LINCOLN CITY/LANCASTER COUNTY PLANNING STAFF REPORT

for January 7, 2003 PLANNING COMMISSION MEETING

P.A.S.: North Creek 1st Addition Preliminary Plat #03008

PROPOSAL: Preliminary Plat 32 lots.

PRELIMINARY PLAT
 NORTH CREEK 1ST ADDITION
 SITE PLAN

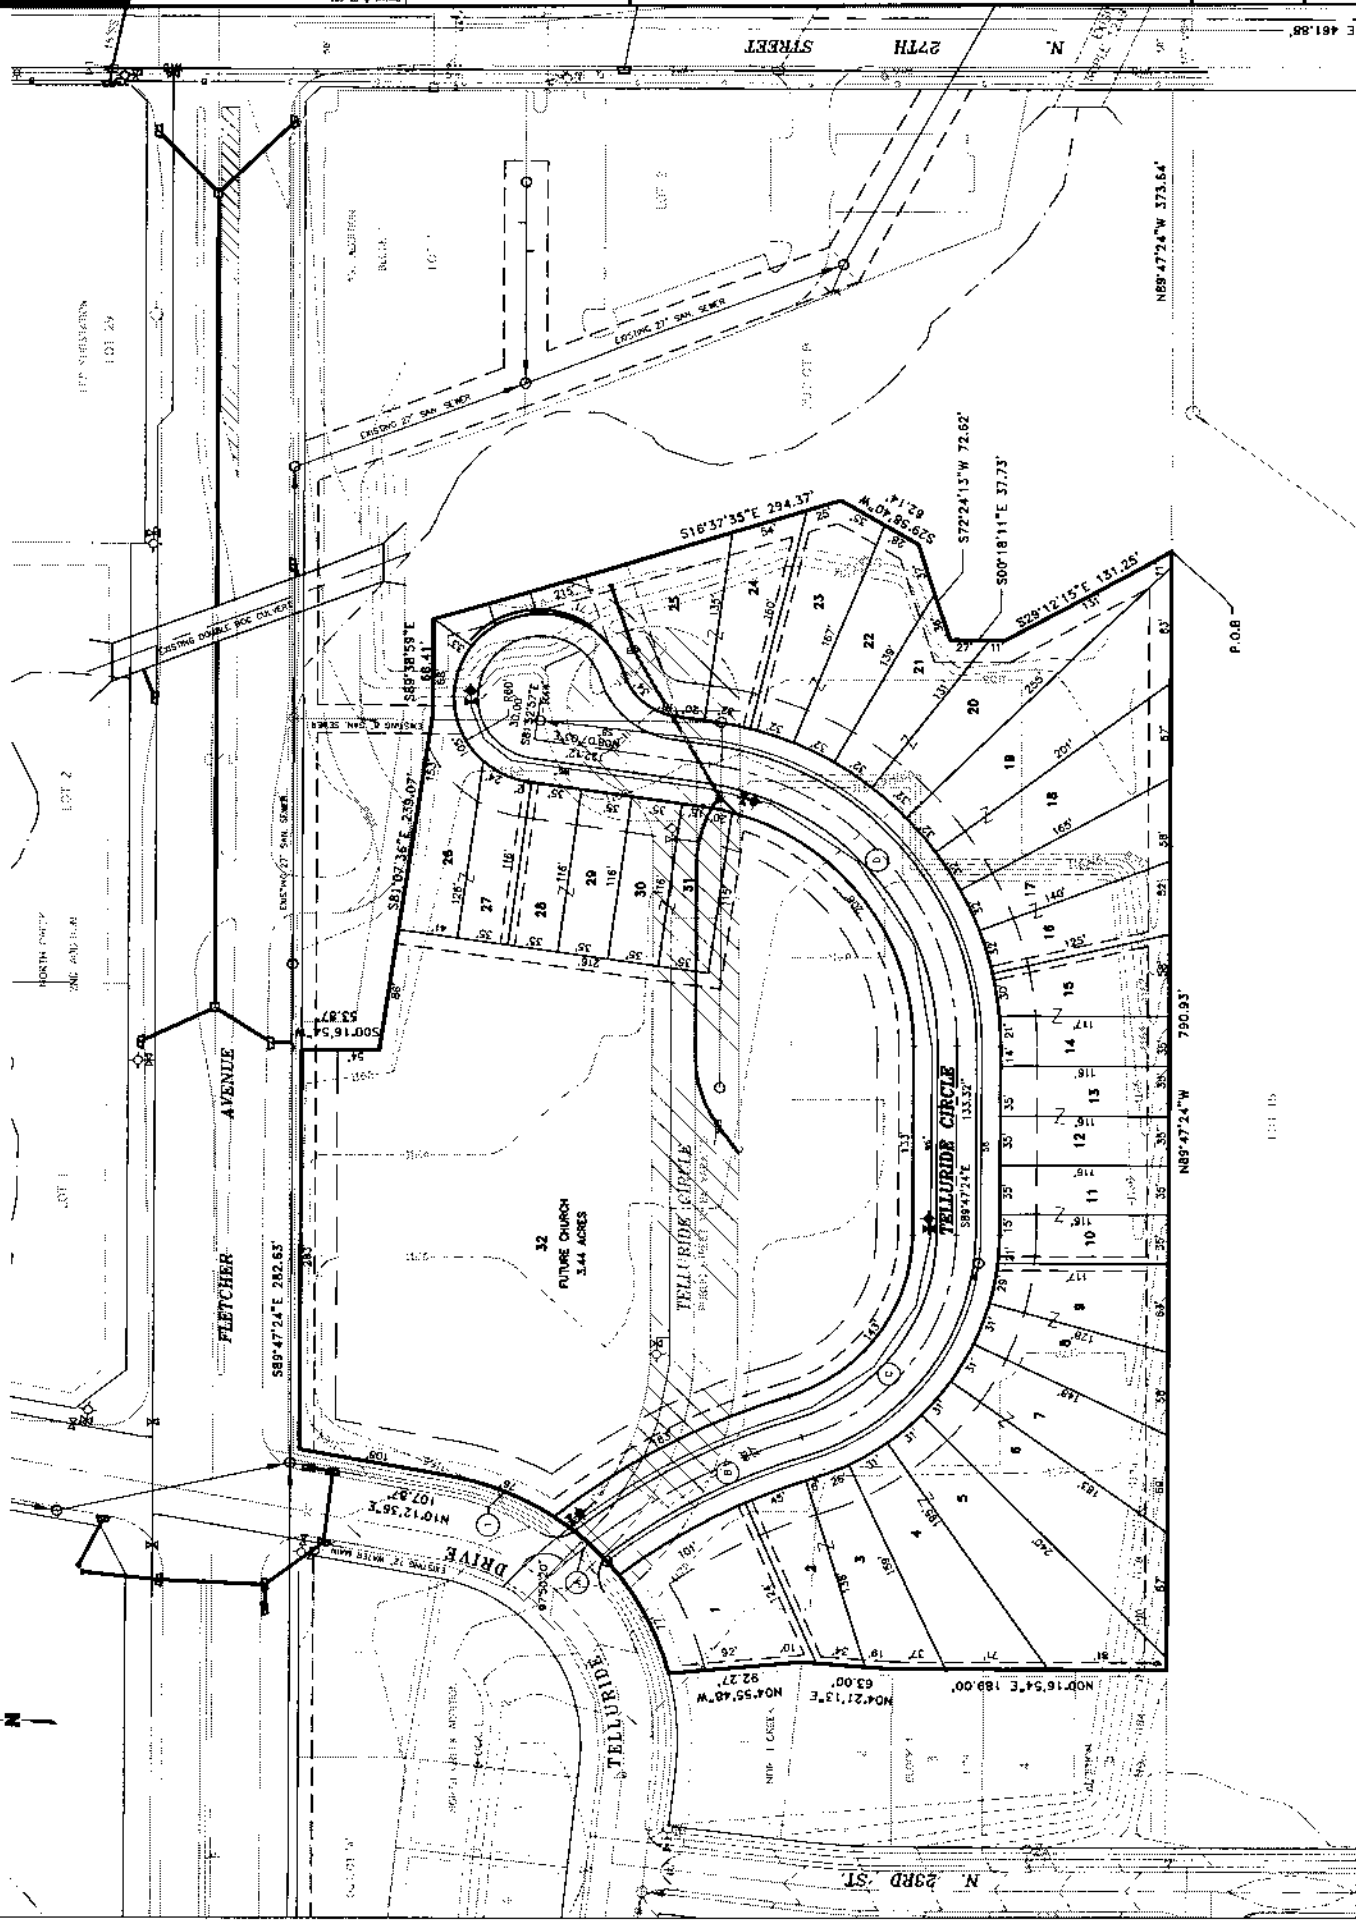
1. Revise the preliminary plat to show:
 - 1.1 Utility Easements required by the Lincoln Electric System.

1. Public Works and Watershed Management comments are addressed as follows:
 - a. Removal of the exiting utilities in Telluride Circle will be scheduled as part of grading and utility construction. Vacation of the existing right-of-way is in process. Public works has indicated this is acceptable.
 - b. The 100-year water surface elevation determined from the study prepared for North Creek Preliminary Plat is listed on the plan. Note that minimum building elevations have been set to be 1.5 feet above the low point of N. 27th Street (4 feet above the design high water) to eliminate potential for damage to structures in the event of overtopping of the street.
 - c. The angle between centerlines of Telluride Circle and Telluride Drive is indicated on the plan. The angle is within 10 degrees of perpendicular.
 - d. The storm sewer system has been resized to accommodate the 10-year flows.

2. The 10- year water surface elevation is listed on the plat.
3. The street name has been changed to Telluride Circle.
4. The requested utility easements have been added to the plat.
5. No comment.
6. The height of the retaining wall has been added to the plan.
7. A table of requested waivers has been added to Sheet 1.
8. There are no existing trees within the bounds of the plat. Note #8 and Note #9 have been deleted.
9. Note #19 (previously Note #22) has been corrected to reference Lot 32.
10. The index of plans has been revised.
11. The lot line between Lot 25 and Lot 26 has been moved to connect to the northeast corner of the plat boundary.
12. The street name has been corrected on the plat.
13. The developer's address has been corrected.
